Docket Number:	24-OPT-01
Project Title:	Perkins Renewable Energy Project
TN #:	262219
Document Title:	Perkins Response to Data Request Batch 3 Part 1
Description:	Response to CEC Data Requests on the Perkins Renewable Energy Project.
Filer:	Emily Capello
Organization:	Panorama Environmental, Inc.
Submitter Role:	Applicant Consultant
Submission Date:	3/17/2025 3:41:18 PM
Docketed Date:	3/17/2025

**California Energy Commission
Perkins Renewable Energy Project
CEC Data Request Response Set #3 for the
Opt-in Application 24-OPT-01**

CEC Data Request Response Set #3 for the Opt-in Application 24-OPT-01

Figure 1 Loop-in Line Transmission Disturbance and Jurisdictional Vegetation

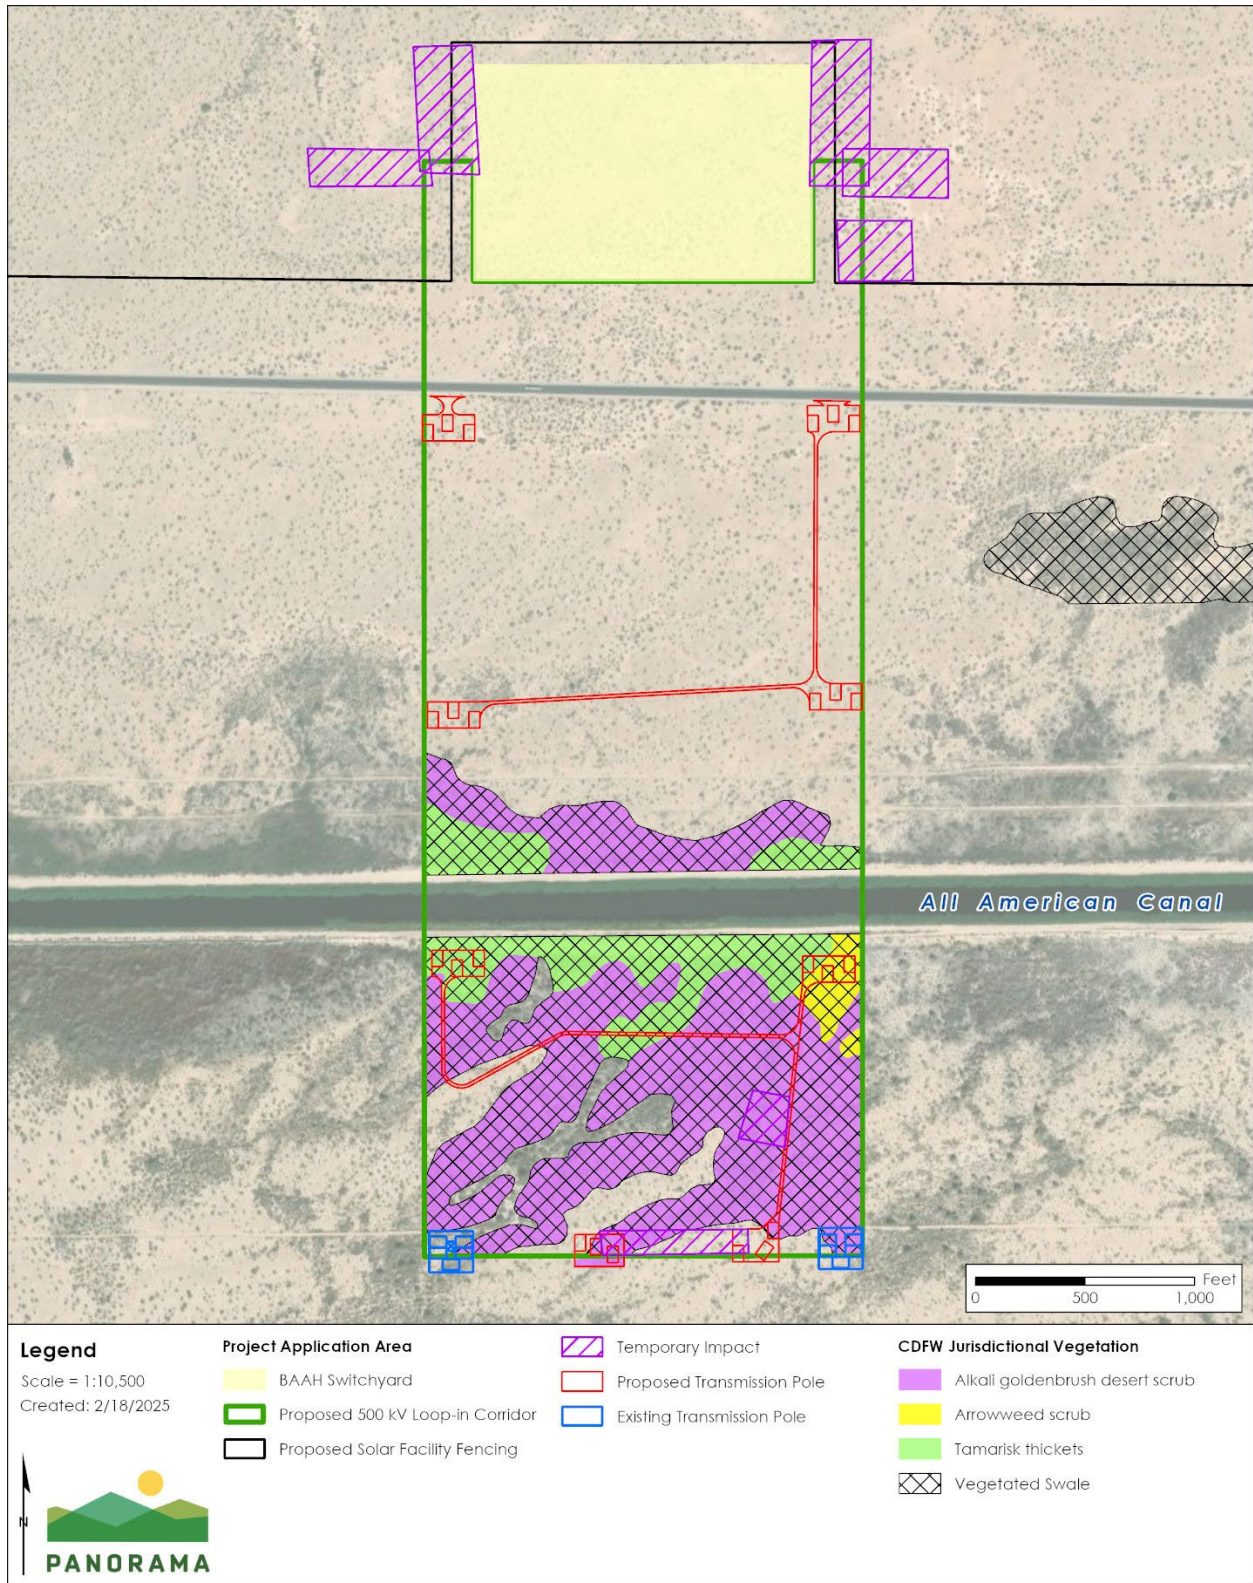
DR BIO-4: Please provide a figure and GIS shapefiles that show the proposed locations of the transmission line structures, including pull sites, within the transmission line corridor in relation to the All-American Canal and associated wetlands.

Response: Figure 1 shows the loop-in line transmission disturbance areas, including temporary disturbance, in association with jurisdictional vegetation. No wetlands would be impacted by the Project as clarified in the updated Aquatic Resource Delineation Report in Attachment A. In addition, no work would occur within the All American Canal. All work areas associated with the construction of the loop-in line poles and access roads are shown in the revised LSAA notification provided in this Response Set #3 as Attachment A. Figure 2 shows all vegetation within the loop-in corridor and the proposed permanent disturbance associated with the loop-in line. GIS Shapefiles have been provided.

Figure 7 Impacts to CDFW Jurisdictional Waters – Perkins Solar Facility

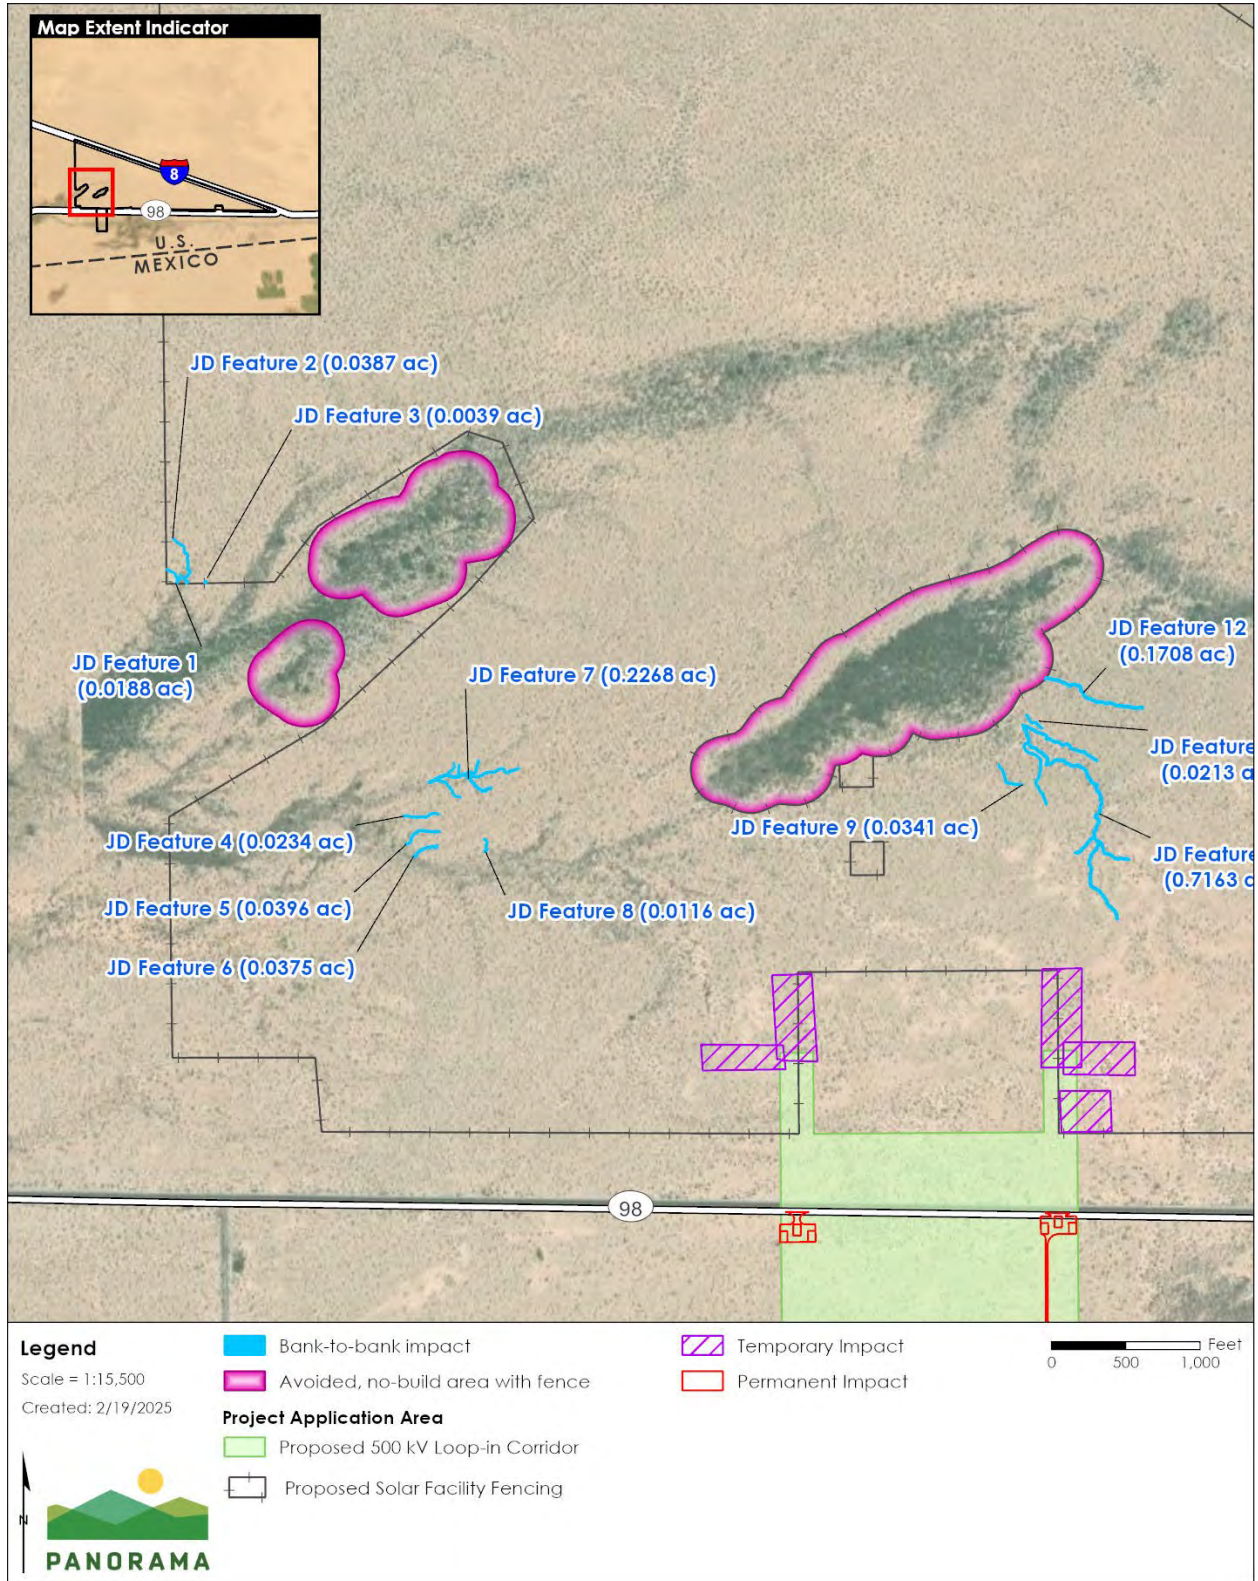
a. LSAA Supplemental Pages, Figure 7 does not show temporary impacts for numbers 16 and 17.

- i. LSAA Supplemental Pages, page 7, Table 2 numbers 1, 2, 3, 12 and 13 do not match Figure 7 acreage numbers.
- ii. Appendix J.5, Tables 1 and 2 both show 1.7 acres of impact to waters of the state and are not broken down between temporary and permanent – the total acreage amount does not match the LSAA application. Please explain in text why these numbers are different or update, as needed. Please update and correct these tables and figures, as needed.
- iii. There are inconsistencies in the data, tables and figures provided in the LSAA and the Waste Discharge Requirements (WDR) Supplemental Pages.

Response: A revised LSAA notification is provided as part of this Response Set #3 in Attachment A. Areas of temporary impact, which were outside of the Project fence have been removed from the application; impacts associated with the solar facility construction would not occur outside of the fence. Acres and linear feet of impacts to waters have been updated based on additional fieldwork and consultation with the agencies

Response: A revised LSAA notification and a WDR application are provided as part of this Response Set #3 in Attachment A. The inconsistencies listed above have been corrected in the revised applications and acres and linear feet of impacts to waters have been updated based on additional fieldwork and consultation with the agencies. Temporary impacts have been removed from the application because no impacts are expected outside the fenceline.

Figure 7 Impacts to Waters of the State

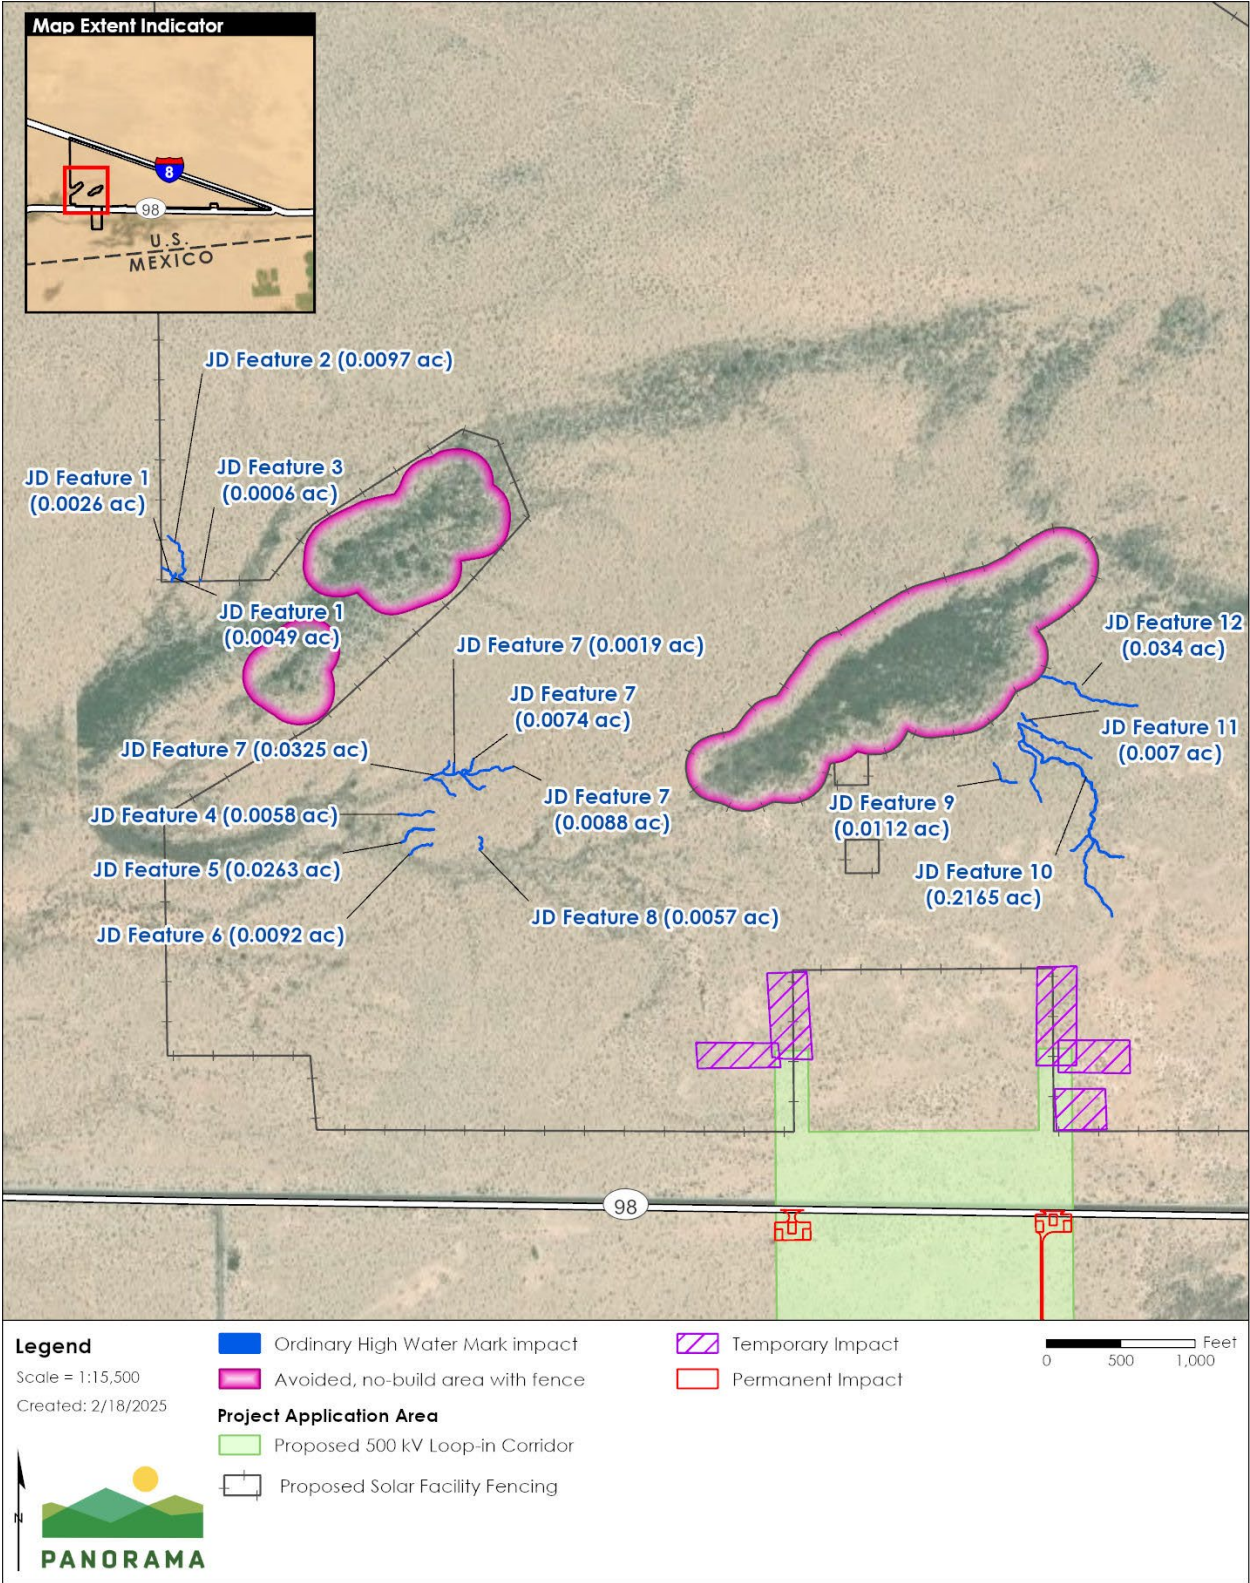
c. WDR Supplemental Pages, Table 3 for permanent impacts to numbers 1 through 3 do not match Figure 7.

d. WDR Supplemental Pages, Figures 7 does not show temporary impacts for numbers 16 and 17.

e. WDR Supplemental Pages, Table 3 for permanent impacts to numbers 1 through 3 do not match Figure 7.

f. WDR Supplemental Pages, Figures 7 does not show temporary impacts for numbers 16 and 17. Please explain in text why these numbers are different or update, as needed. Please update and correct these figures, as needed. Please revise to clarify the areas of temporary impacts, as well as update the notification to include all vegetation types and impacts associated with the updated jurisdictional delineation per DR BIO-3. Please revise all tables and figures to include the correct information.

Response: A revised WDR application is provided as part of this Response Set #3 in Attachment A. The acreage estimates have been updated.

Response: A revised WDR application is provided as part of this Response Set #3 in Attachment A. Areas of temporary impact, which were outside of the Project fence have been removed from the application; impacts associated with the solar facility construction would not occur outside of the fence.

Response: A revised WDR application is provided as part of this Response Set #3 in Attachment A. The acreage estimates have been updated.

Response: A revised WDR application is provided as part of this Response Set #3 in Attachment A. Areas of temporary impact, which were outside of the Project fence have been removed from the application; impacts associated with the solar facility construction would not occur outside of the fence.
